**National
Fenestration
Rating Council,
Incorporated**

**NFRC 2001 and 2004 Technical
Interpretations**

Published: March, 2005
Last Updated: September, 2006
Applicable to 2001 and 2004 Procedures

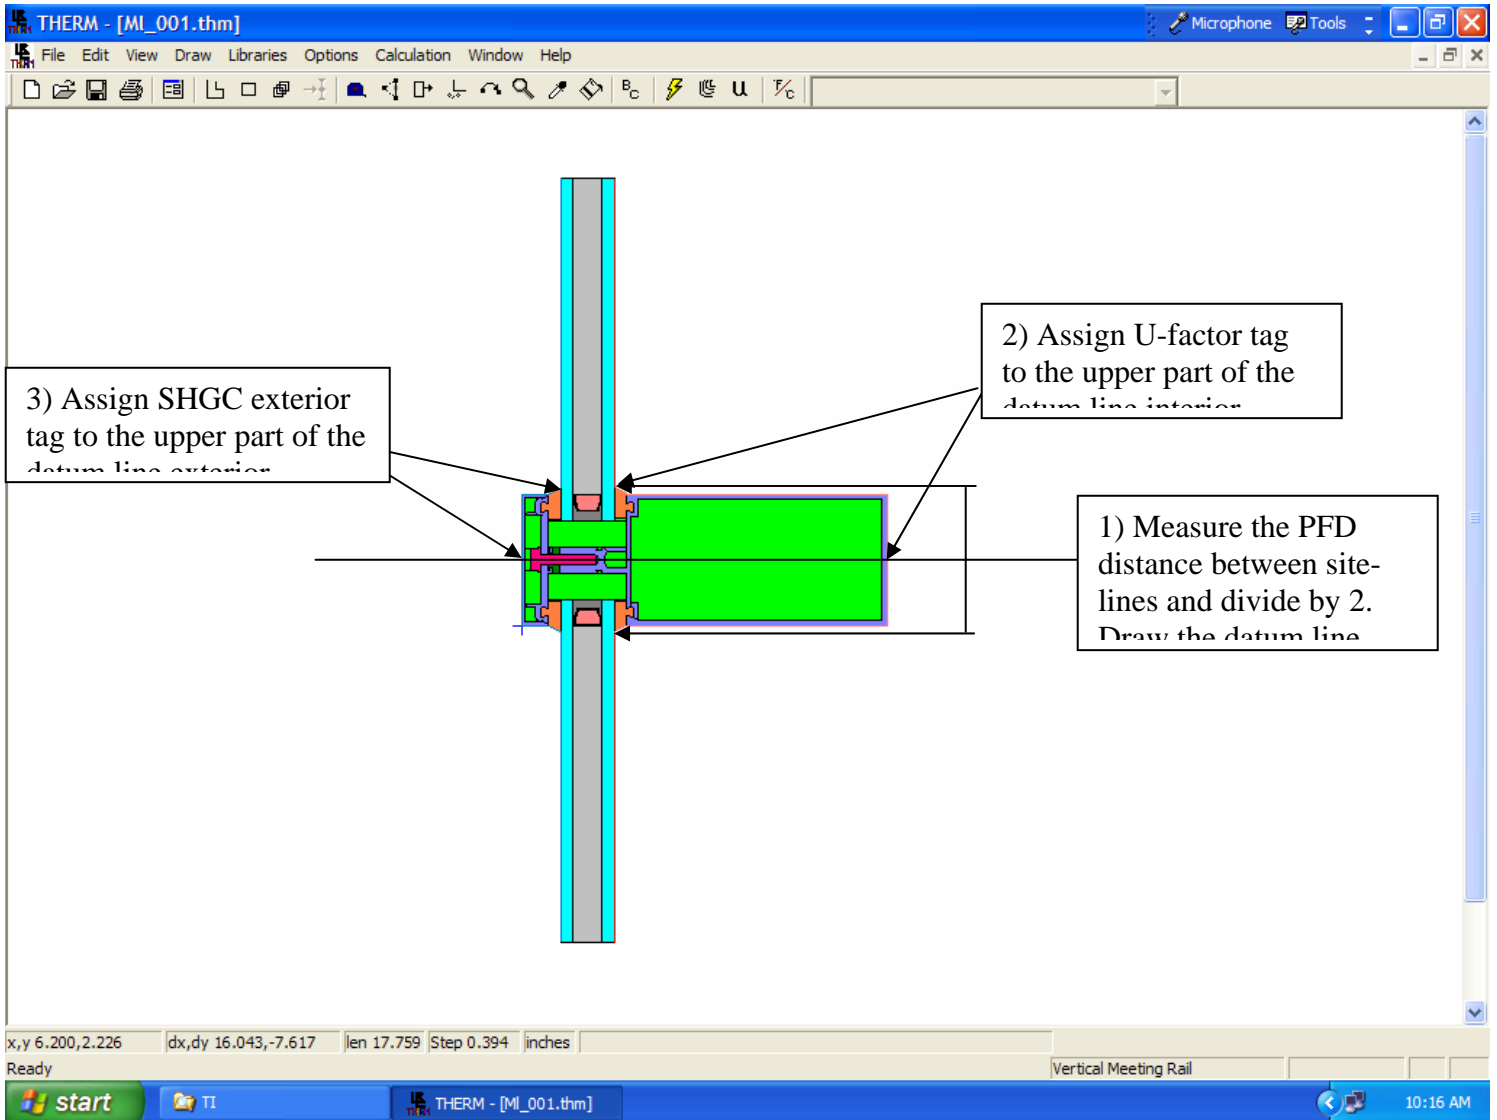
Interpretation Requested:
<p>a) For a Curtain Wall, how can the Jambs, Head and Sill cross-sections be modeled to reflect center line to centerline modeling?</p> <p>b) For a Window Wall or strip window, how can the Jamb cross-sections be modeled to reflect center line to center-line modeling?</p>

a) Simulate the full vertical intermediate member twice. Once with the left glass replaced with wood, which is the same thickness as the IG unit, and once with the right glass replaced with wood, which is the same thickness as the IG unit. The wood shall extend to the original site line (This is for the left and right jambs).

b) Simulate the full intermediate horizontal member twice. Once with the top glass replaced with wood, which is the same thickness as the IG unit, and once with the bottom glass replaced with wood, which is the same thickness as the IG unit. The wood shall extend to the original site line (This is for the head and sill).

Produce the test sample with the same cross sections as simulated in steps a & b.

The reported product simulated value shall be based on the simulations as performed in steps 1 through 7. Validation is checked by comparing the values obtained by simulating the product using steps a & b and the physical test results.

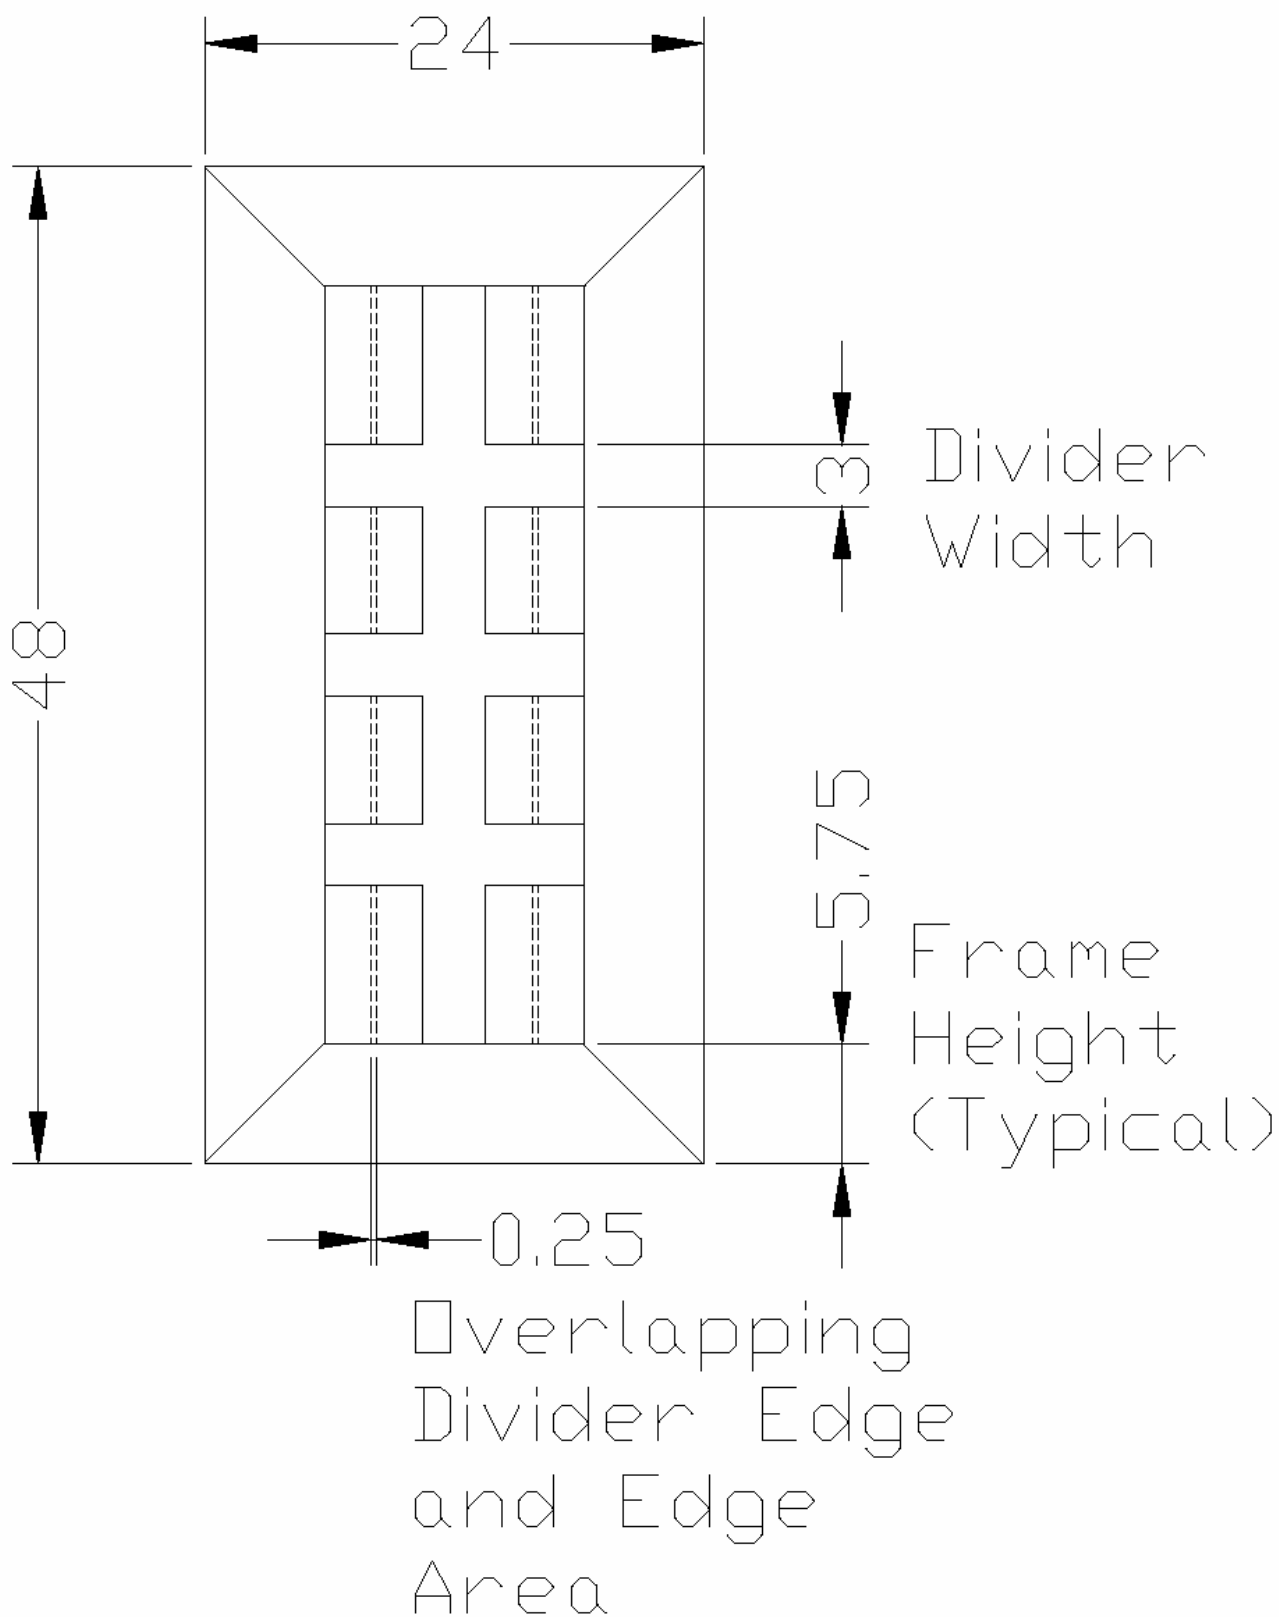
Interpretation Requested:
A standard window product is made with and without dividers. The dividers must be modeled in accordance with NFRC 100, but the default divider pattern does not allow for the full 63.5mm of edge-of-glass (divider) to be modeled. How should this product be area-weighted? (See attached drawing)

Interpretation :
<p>This interpretation shall apply to all fenestration products.</p> <p>Increase the overall dimension(s) by the distance of the overlap, thereby restoring the 63.5mm edge and divider-edge dimensions, leaving the center-of-glass area equal to zero.</p> <p><i>Note: This would be the same as the interpretation for transoms and sidelites (TI-100-99008)</i></p>

Figure:1

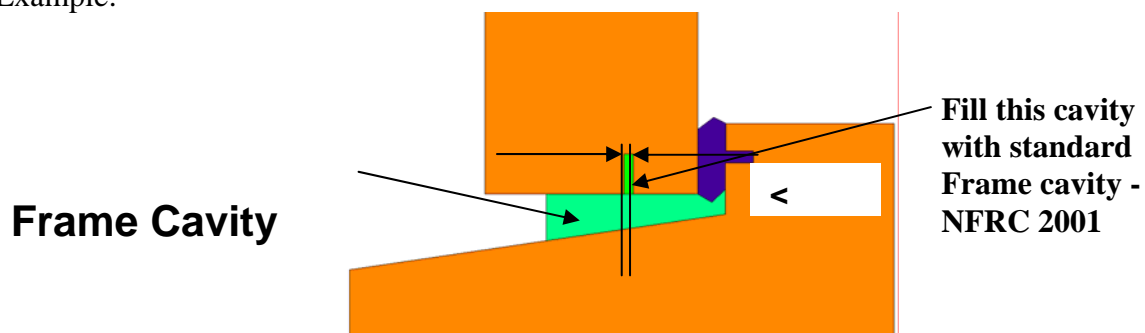
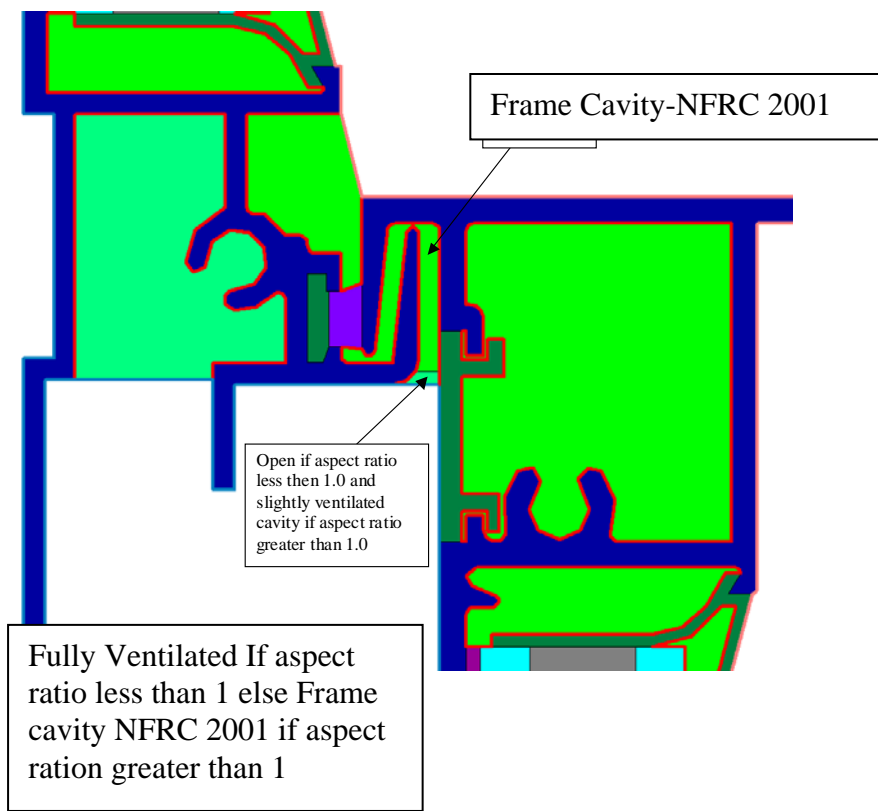
When defining exterior Slightly Ventilated Cavities, should cavities $\leq 2\text{mm}$ within the defined Slightly Ventilated Cavities be treated as standard Frame Cavities?

Yes. When an exterior cavity has been defined as a “Frame Cavity Slightly Ventilated NFRC 100-2001” per the simulation manual and now engulfs cavities that have openings less than or equal to 2mm, the cavities $\leq 2\text{mm}$ shall be filled with the standard “Frame Cavity NFRC 100-2001.”

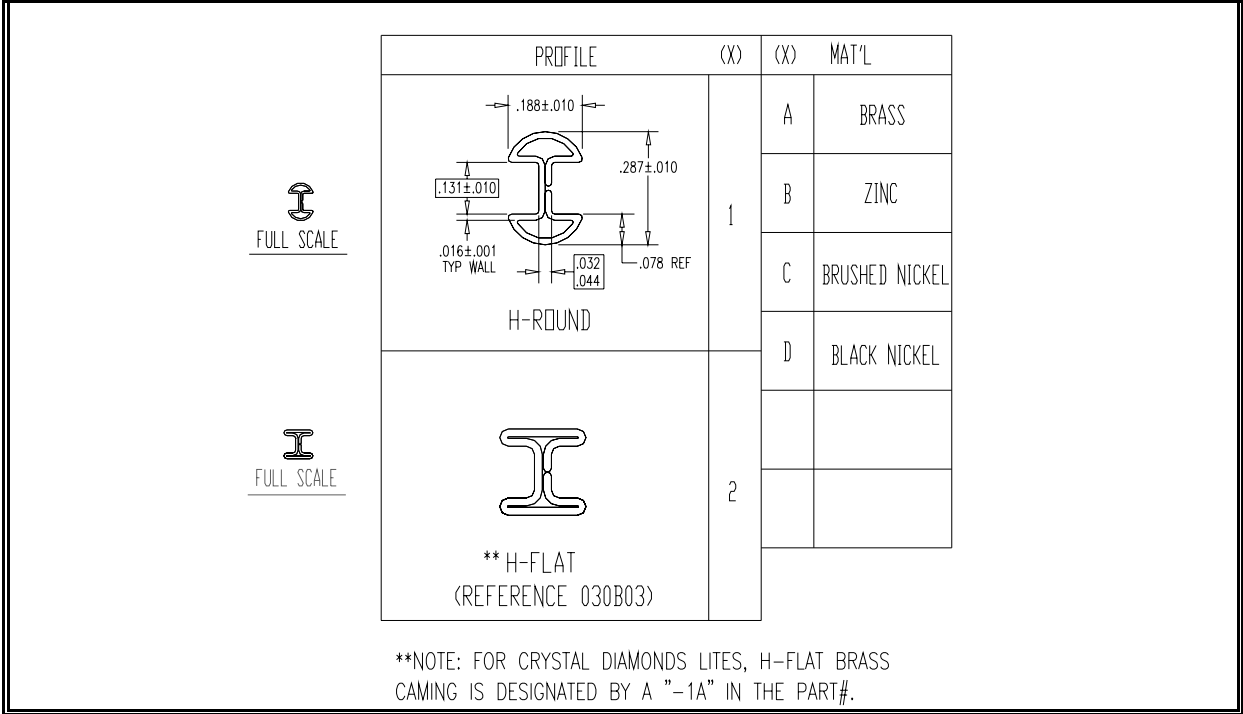
Interpretation Requested:
When using the NFRC default caming for swing door simulations which shape and material is considered the default configuration?

Interpretation :
<p>The flat caming (H -Bar) shall be used as the default shape. Lacquered Yellow Brass conductivity = 119 w/m-k, e = 0.9 (source ASHRAE Handbook of Fundamentals) shall be the default material.</p> <p>Caming drawing dxf file is available from the NFRC website. Drawing attached</p>

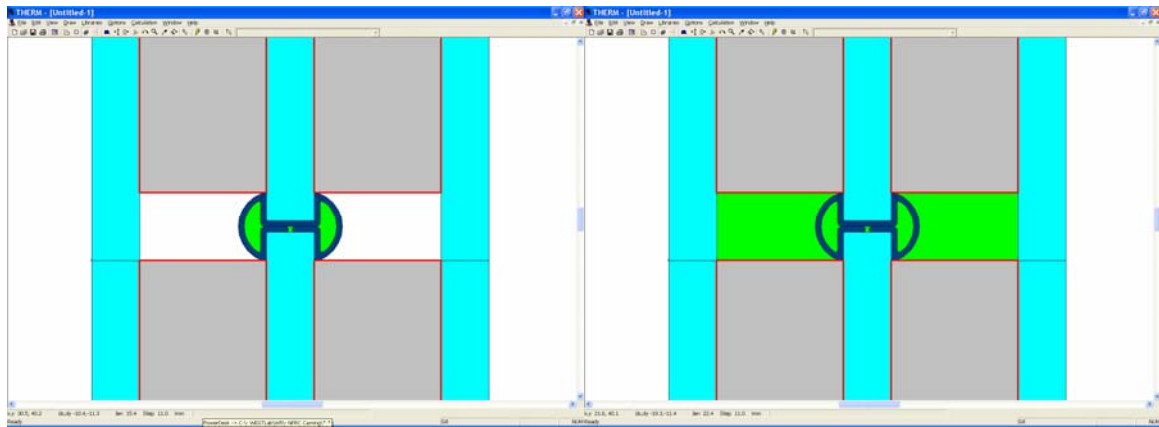
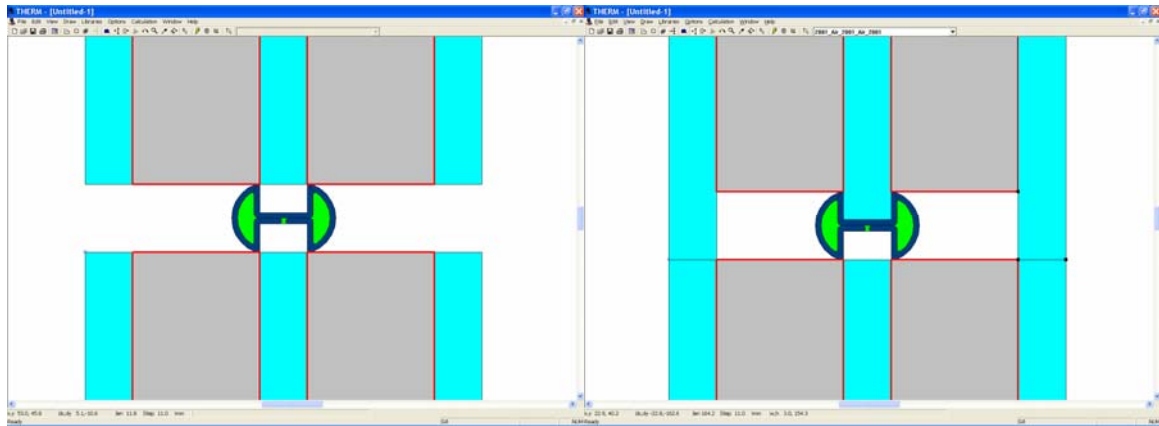
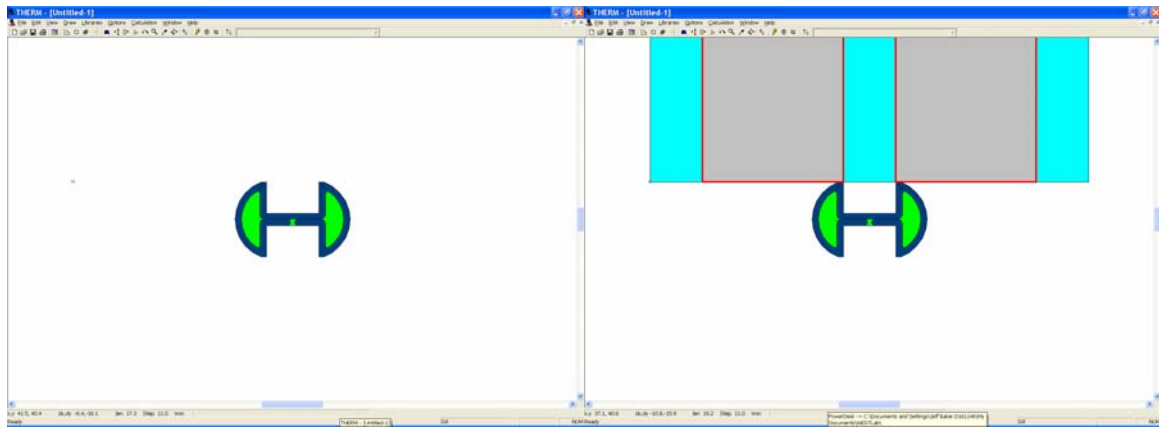
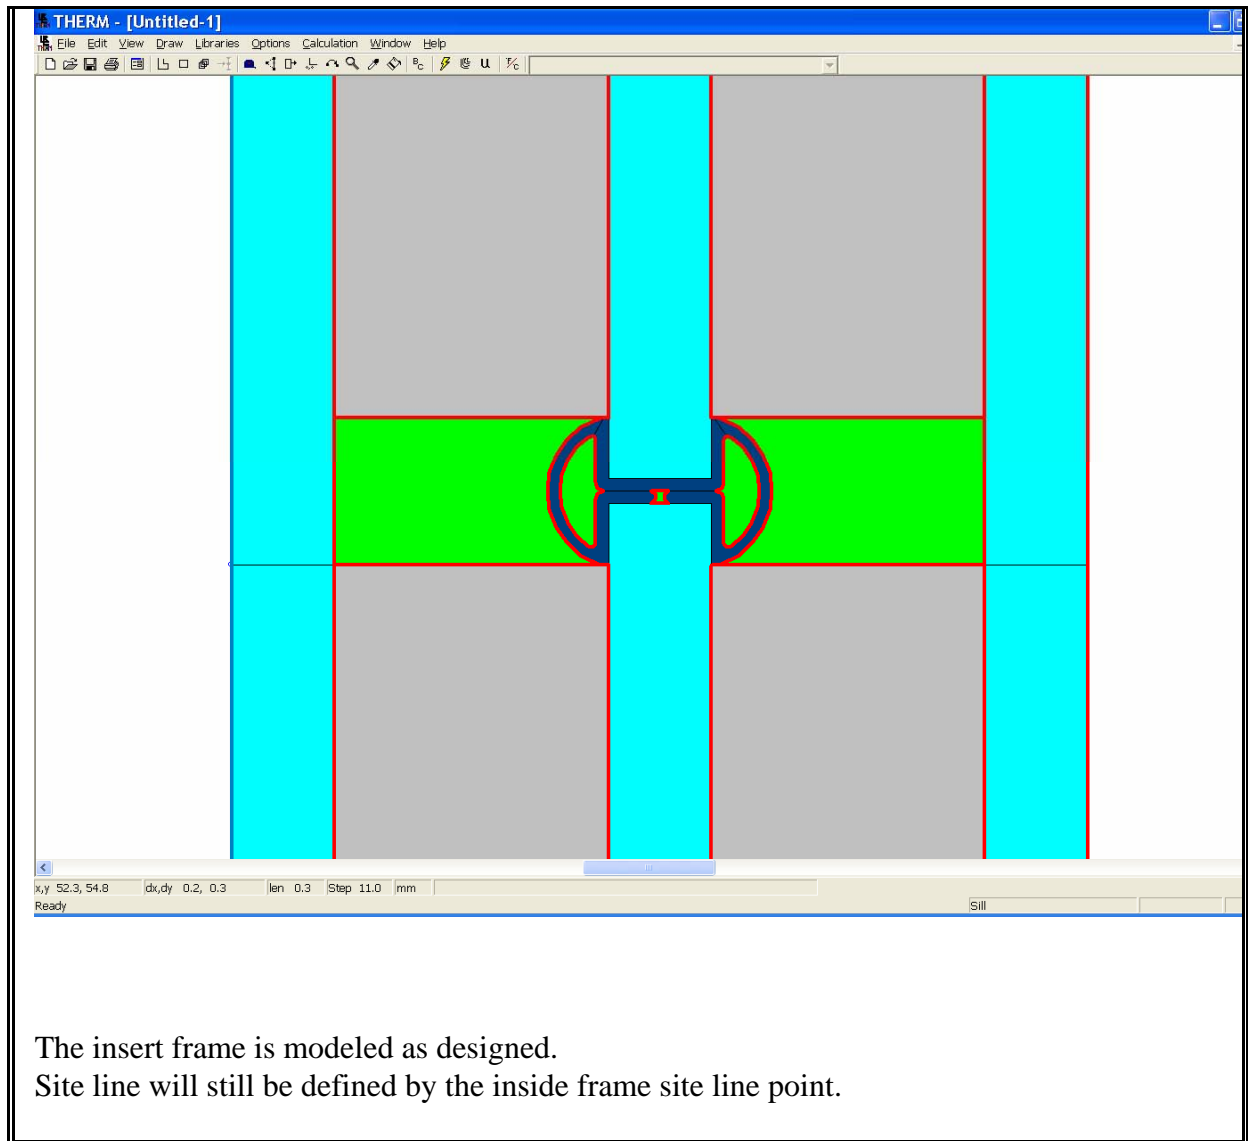
How is the IG unit with intermediate pane having lead divider and insert frame modeled? For U-factor and SHGC?

Camming shall be modeled in accordance with section 8.3.1 of NFRC simulation manual and as per steps defined below.

The insert frame is modeled as designed.
Site line will still be defined by the inside frame site line point.
